SERVICE TECHNICAL INFORMATION

REF. NO. : SI-97-019
CUSTOMER RELATION SERVICE DIV.

MODELS : Z-M2800/M2900/VM280/VM290, NSX-F9/V800/V900
SUBJECT : No power/Sound Distortion due to power IC defect.
CONTENTS : Due to power IC(STK-419-***defect, it is caused to no power or sound distortion. It requires to modify following contents to all repair items when replace in the above mentioned power IC.

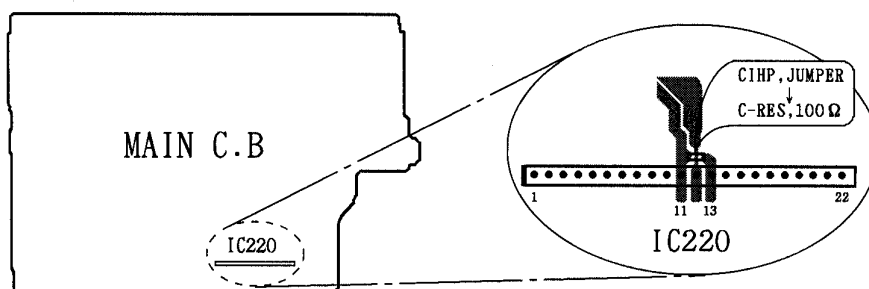
MEMO : This modification is required to do all in the above mentioned models for repair even power IC is not damaged.

REMEDY : To replace parts from chip jumper to chip resistor, $100\Omega \cdot 1/8W$, between pin① and ⑬ of IC220.

Ref.	PARTS CODE	PARTS NAME
	88-128-101-010	C-RES, 100Ω 1/8W
